EASTERN CORRIDOR SEGMENTS II AND III (PID 86462)

COMBINED LINWOOD/EASTERN INTERCHANGE & US 50/RED BANK INTERCHANGE FOCUS AREAS ADVISORY COMMITTEE MEETING NOTES

February 14, 2018
May 22, 2018
September 7, 2018
December 12, 2018

Figure I-26B
**CONTINUOUS RIGHT TURN LANE FROM
BEECHMONT CIRCLE TO WOOSTER ROAD**

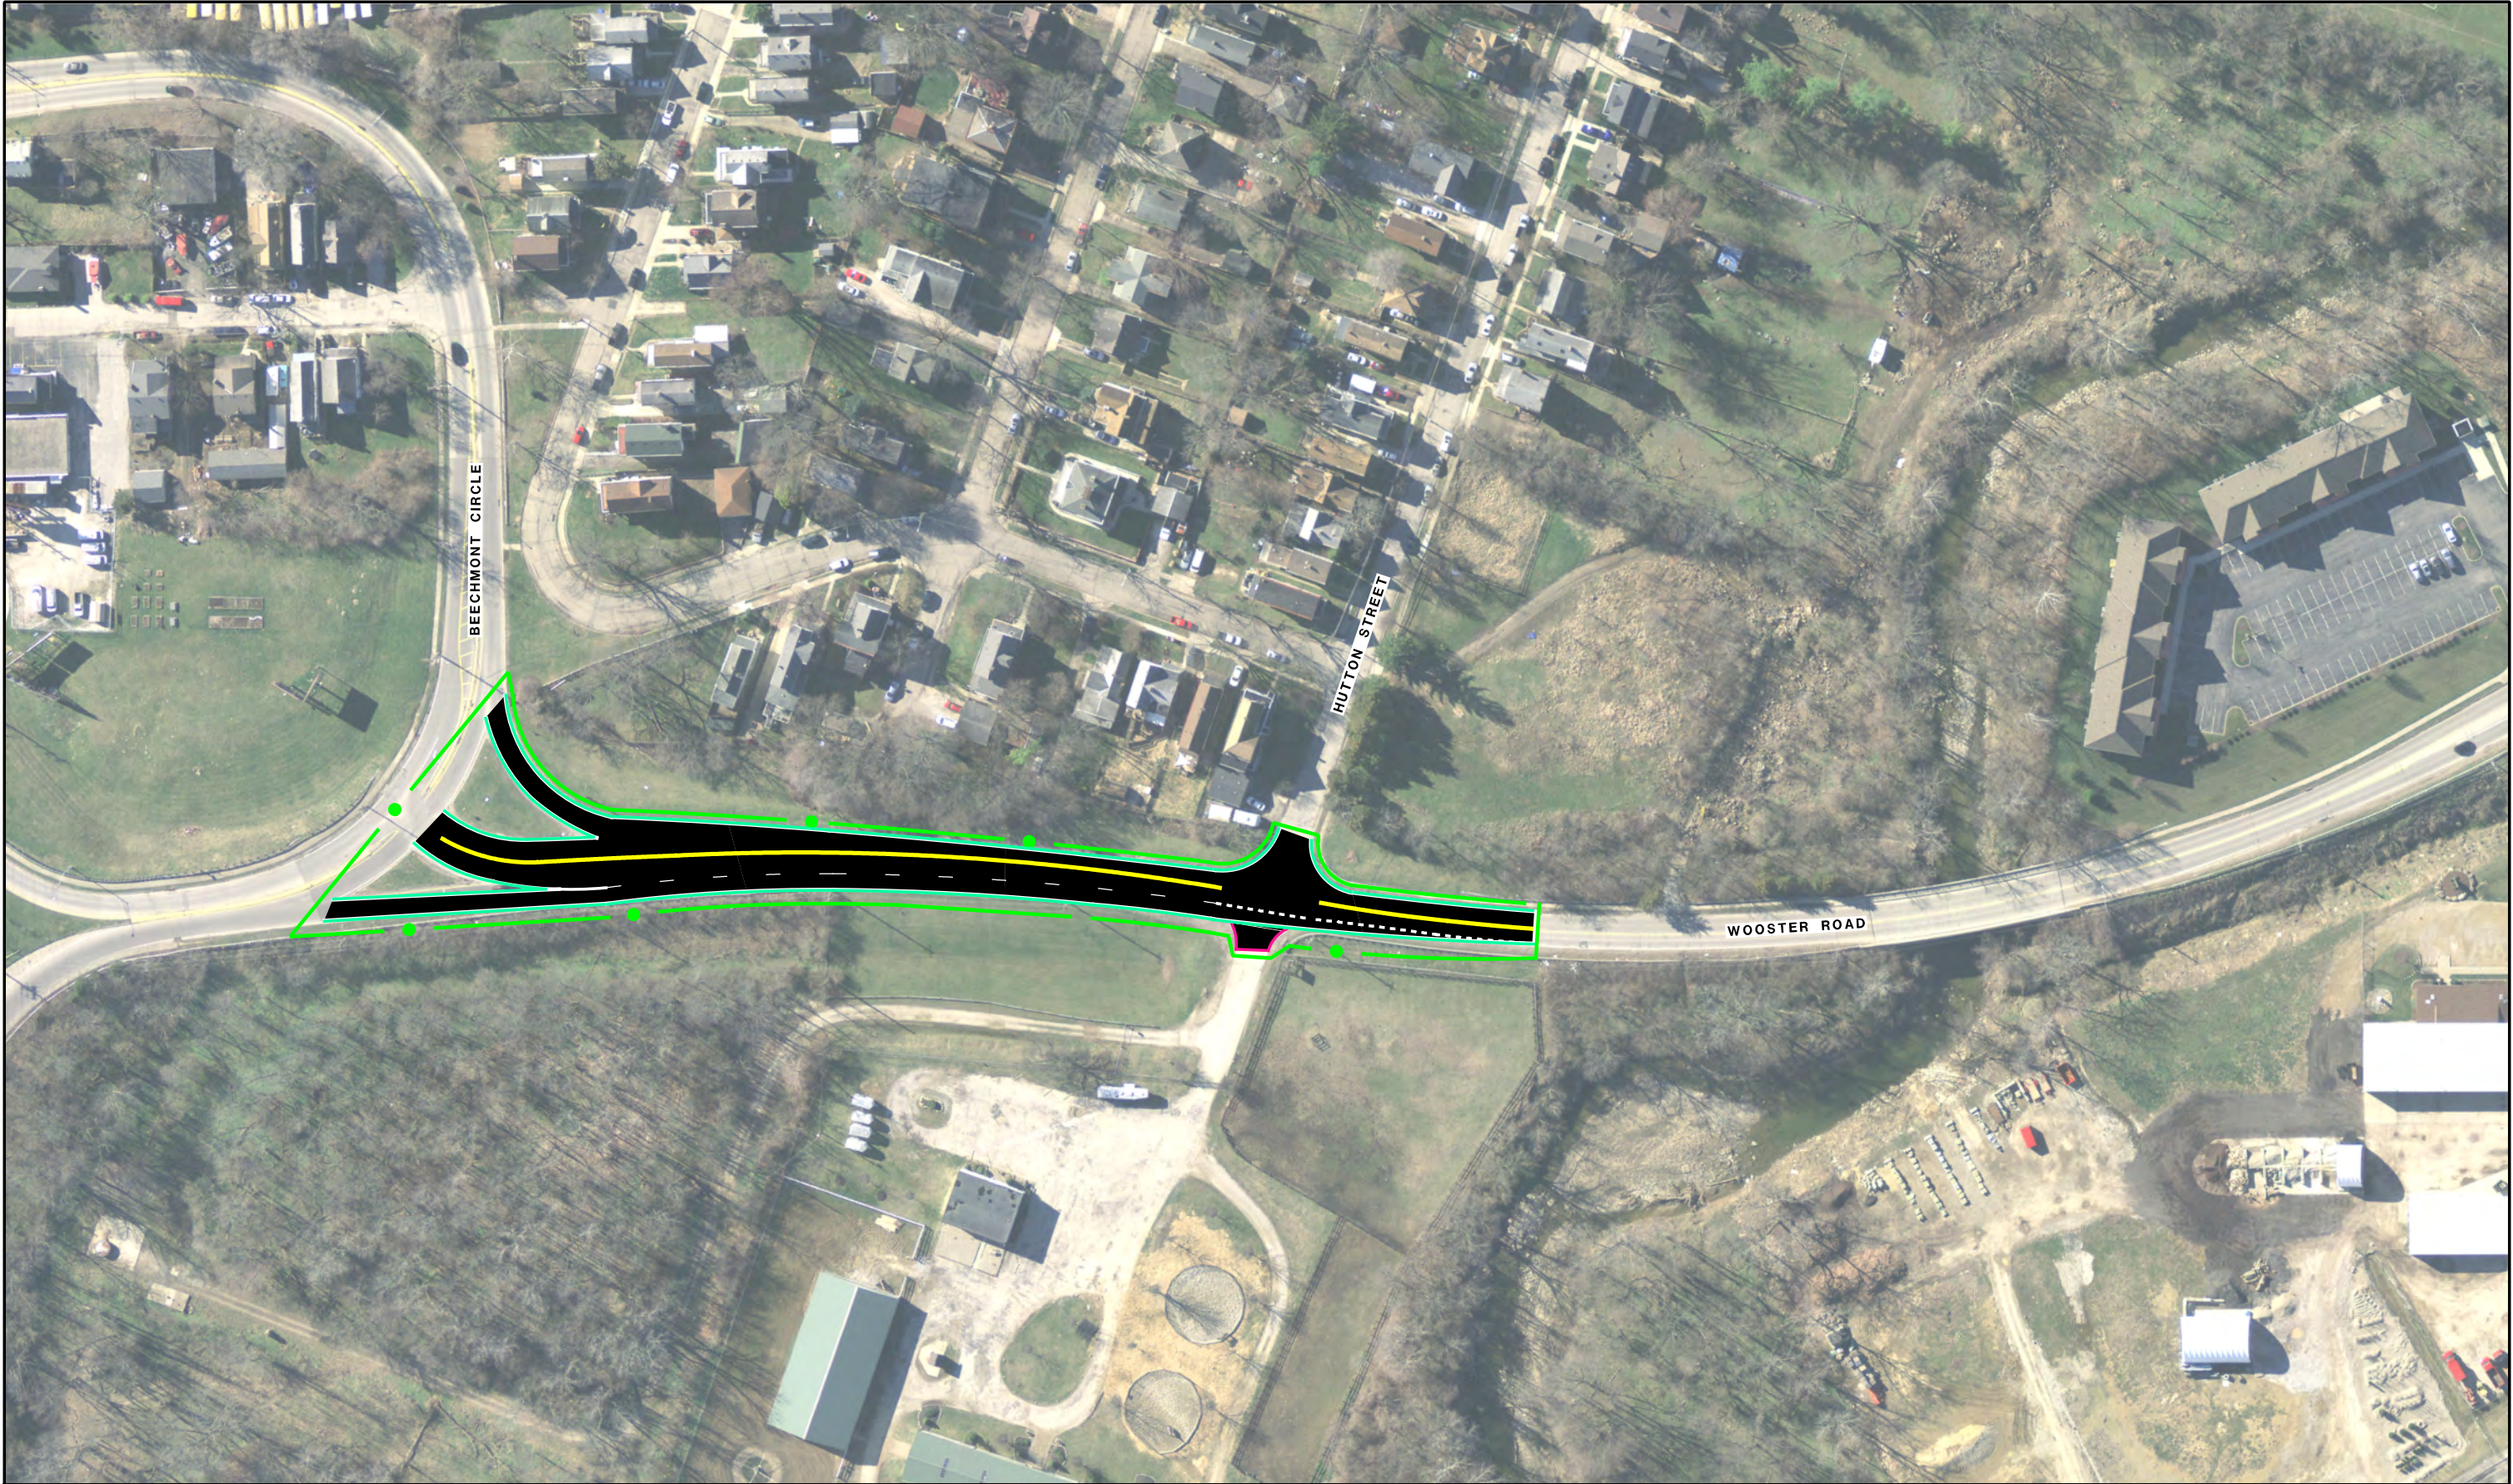
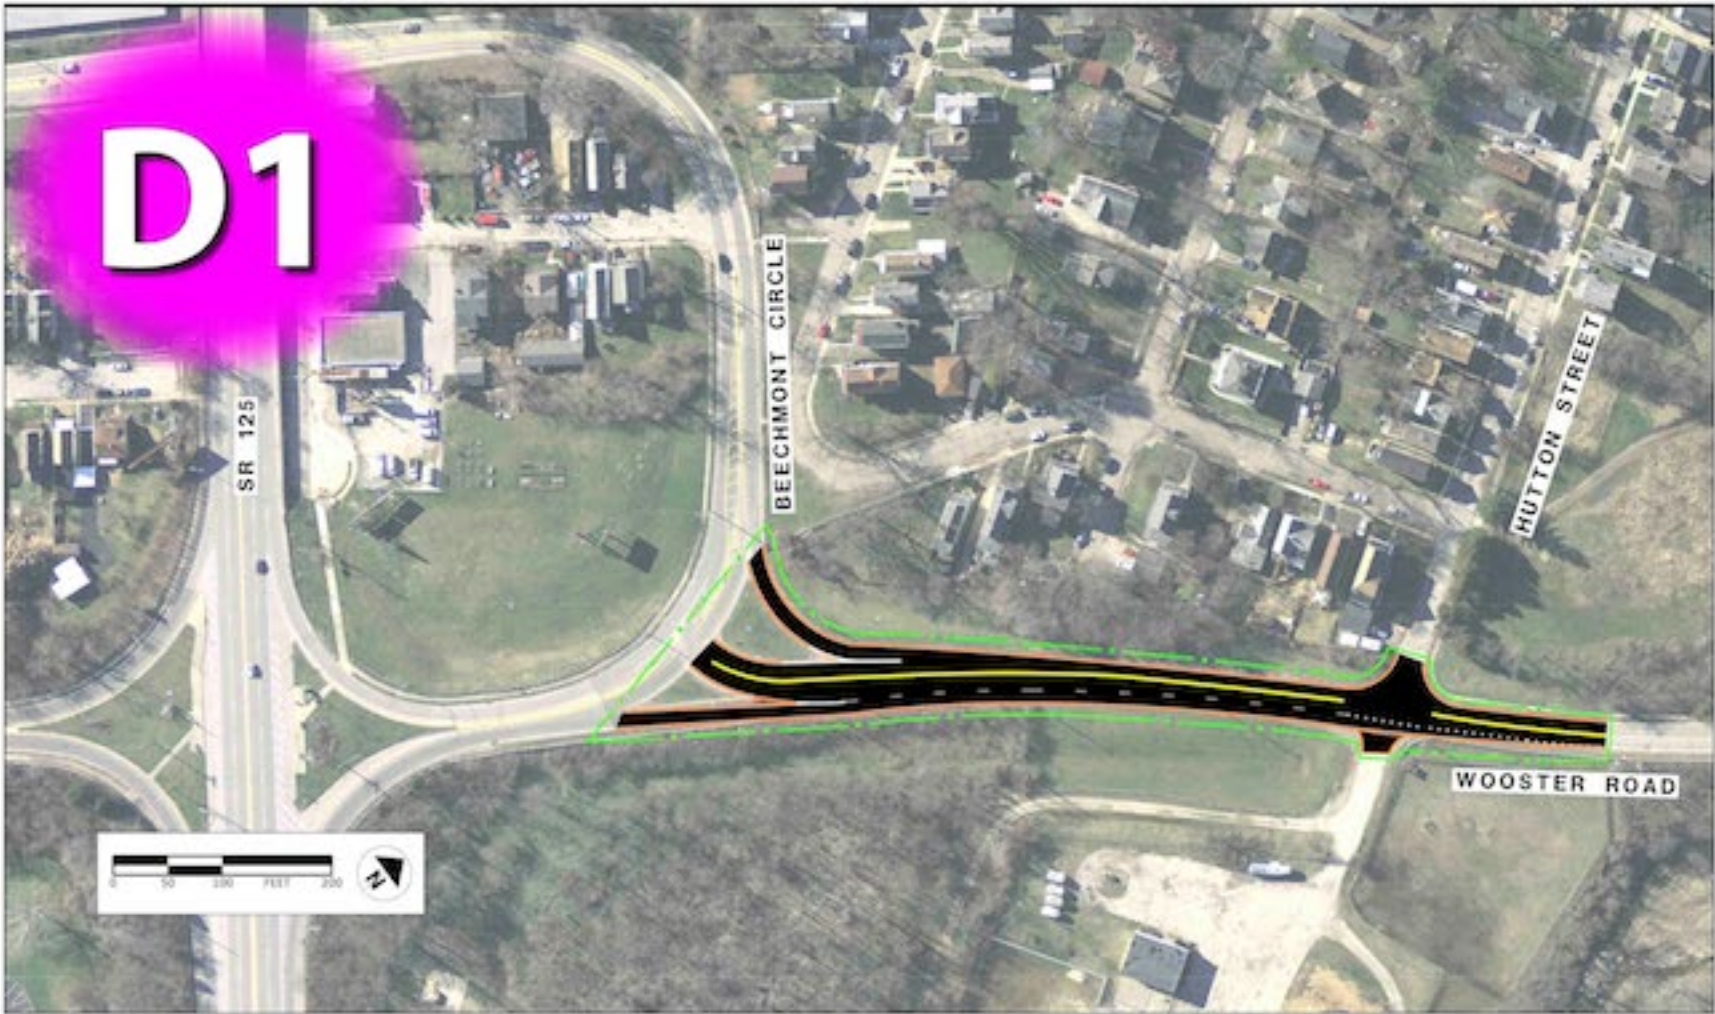
- Concept removes the median on Wooster to allow for two lanes. This creates a continuous right turn lane at Beechmont Circle for turns onto Wooster from SR 125, so those drivers can merge instead of coming to a yield line. The concept includes minimal widening.
- No additional comments received following the 9/7 meeting.

PRIORITY: LOW

Figure X-2B-1
SINGLE POINT URBAN INTERCHANGE

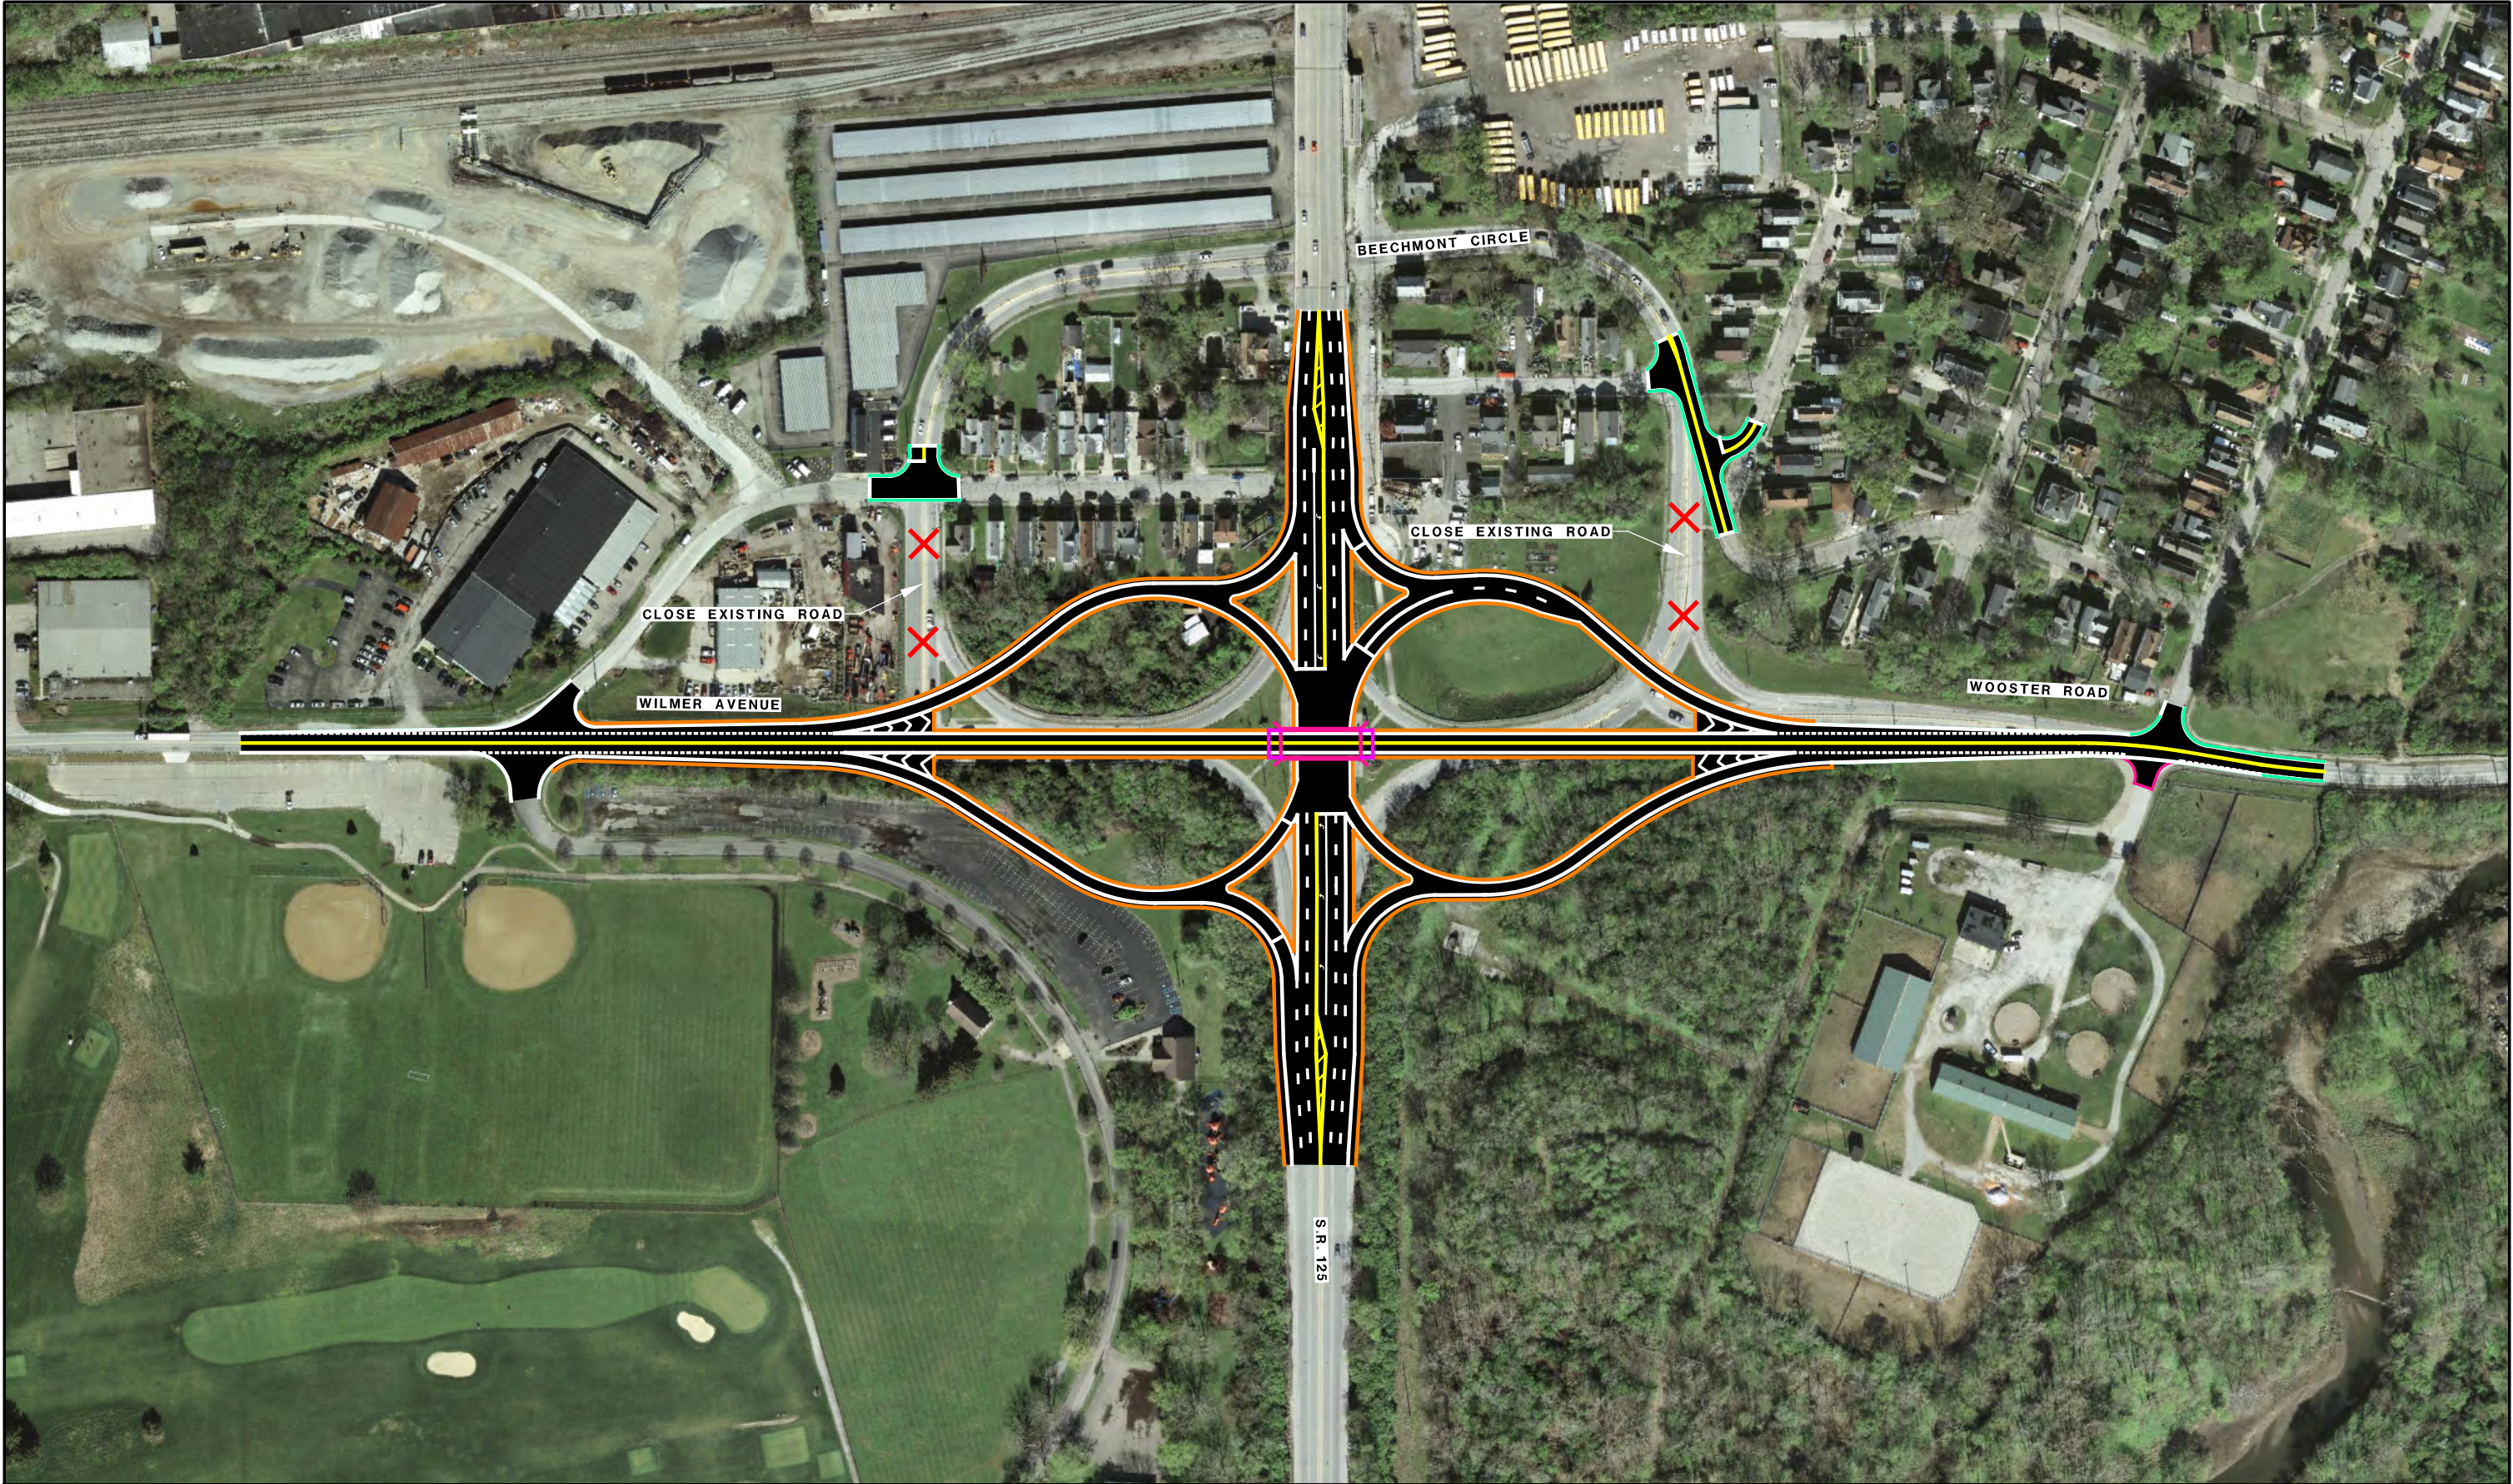
- No further study. The traffic signal does not perform well and the concept requires construction of a significant structure.

RECOMMENDATION: NO FURTHER STUDY
